**BEFORE A HEARINGS PANEL OF THE GREATER WELLINGTON REGIONAL COUNCIL  
AND MASTERTON DISTRICT COUNCIL**

**FOR** the proposed upgrade of the Masterton Wastewater Treatment Plant

**SUPPLEMENTARY STATEMENT OF EVIDENCE OF CHRIS HICKEY  
ON BEHALF OF MASTERTON DISTRICT COUNCIL**

**RESPONSE TO OFFICERS' REPORT**

**Figure 1** Comparison of interflood period relationships between Manawatu and Ruamahanga rivers (NIWA data, M. Duncan).

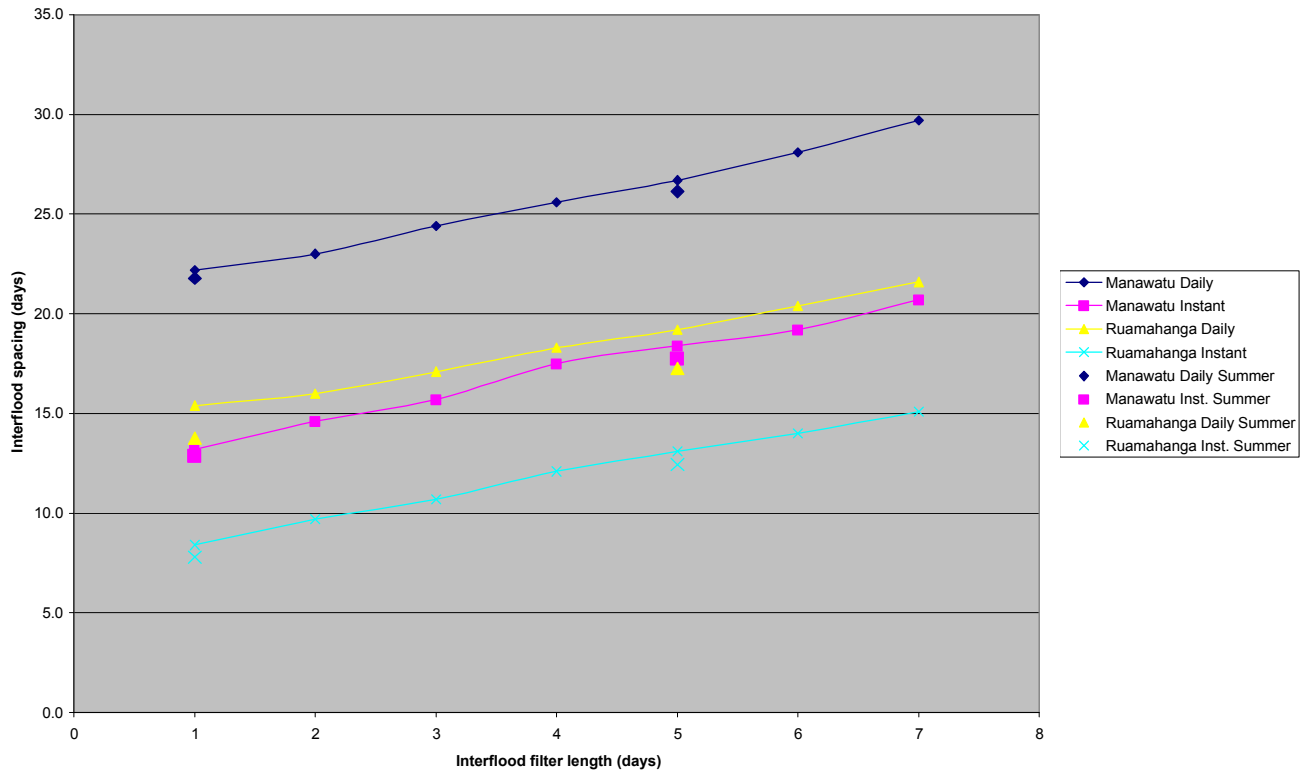
*The proposed in-river DRP standard of 0.012 g/m<sup>3</sup> (Table 4) was derived in strict accordance with the periphyton biomass model in the national periphyton guidelines (Biggs 2000), focusing on the protection of aesthetics/trout angling and taking into account the average number of days for periphyton accrual over the course of a year (19 days based on the full data record dating back to 1977, with a "filter" period of 5 days). We consider our standard to be more appropriate than the guideline proposed by NIWA (0.030 g/m<sup>3</sup>) which was based on a 13-day accrual period calculated from summer data only and a "filter" period of just one day. A standard of 0.012 g/m<sup>3</sup> also relatively closely aligns with standards in other regional plans (e.g., Horizons and Hawke's Bay both have a standard of 0.015 g/m<sup>3</sup> for some catchments) and the applicant's own predictions of the downstream concentration after full mixing (refer paragraph 70).*

- 21.2** The basis for our site-specific DRP guideline was field studies undertaken in 2003 which provided the confidence that summer freshes above 3x the summer median flow (6.5 m<sup>3</sup>/s) would effectively scour and ‘reset’ the algal periphyton communities at Wardells Bridge. These results are shown in the NIWA report (NIWA 2003, Fig 5.2, p13) and provide the basis for the site-specific guideline development (NIWA 2004). We have provided detailed justification for our decisions of accrual period and flood “filter” period in our report (NIWA 2004). These clarifications were required for many measures because the MfE (2000) guideline document is not descriptive or methodological, with key variables such as ‘accrual period’ or ‘median flow’ not being defined in the document. Our field studies, combined with the routine monitoring data, provide the basis for our confidence in the approach we have taken.

- 21.3** There should not be an expectation that all DRP guidelines should be “align” as indicated by the Officers. Because not all rivers hydraulically similar, some being slow moving but others with frequent floods, this key variable will affect the site-specific guideline, with the guidance provided in the MfE (2000) document. Comparative data for the Manawatu and Ruamahanga rivers (Figure 1) shows the markedly longer inter-flood spacing in the Manawatu, with a strong (but similar) effect for the interflood-filter period in both rivers. These data show that flood effects will not be the same in these two river systems. Other field data has shown that the presence of high number of macroinvertebrate grazers can prevent periphyton bloom formation even at very high nutrient concentrations (Welch et al 1992). Together, these studies indicate that site-species DRP guidelines will vary markedly between river systems and that a fixed “standard” value approach is not appropriate for all situations.
